Department of Environmental Quality

RE: North Butte ISL Operation, Permit No. 632

ANNUAL INSPECTION REPORT

SUBJECT: Cameco Resources' North Butte Project

Photo No. 3 Looking north to east across future Mine Unit No. 1 where delineation or infill drilling has been completed and drill holes and mud pits are in different stages of sealing and reclamation.

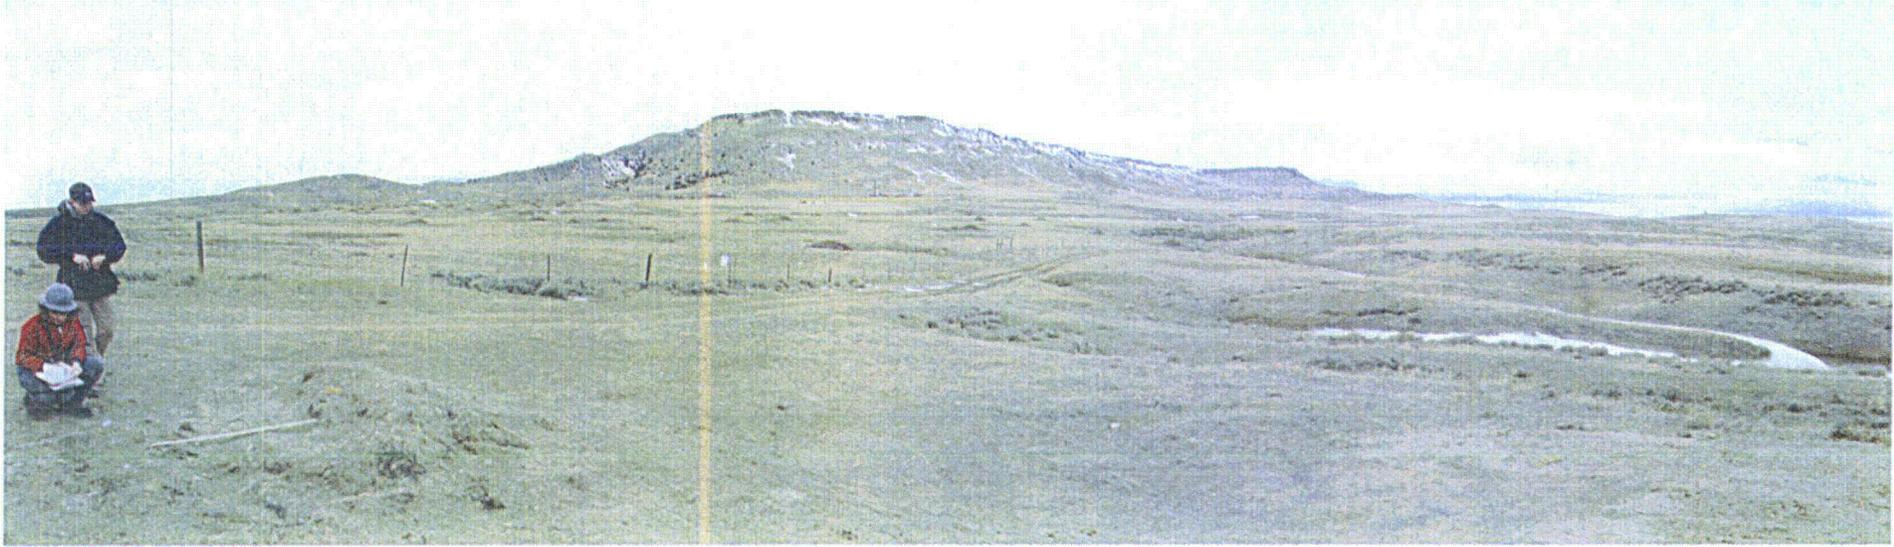
Historically, the property was drilled in lines of 50 holes on fences (rows) 200 feet apart (Photo No. 3). Now the well field areas are being drilled on a 100'X100' pattern. With four drill rigs running, they expect to complete drilling in Mine Unit 2 by July or August of this year.

Photo No. 5 Looking north-northwest at reclaimed drill hole in south end of Mine Unit 1.

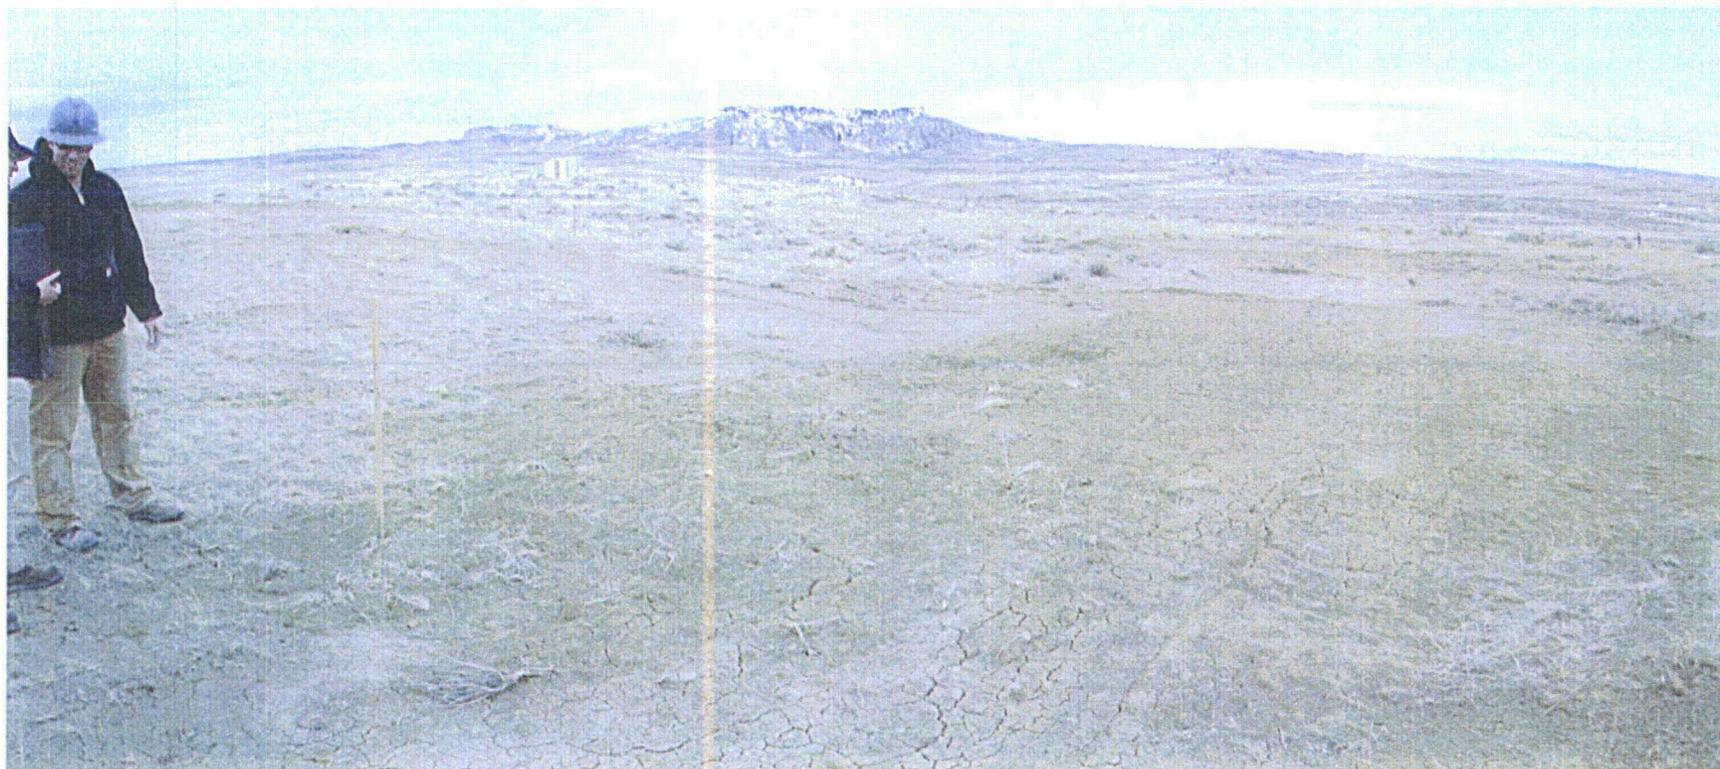
One potential problem noted was that a couple of locations were found where the drill seeding had not been seeded on the contour with the drill tracks running up and down the slope. Experience has found that the grass sprouting in tracks oriented this way is not nearly as effective at retarding erosion as that seeded on the contour.
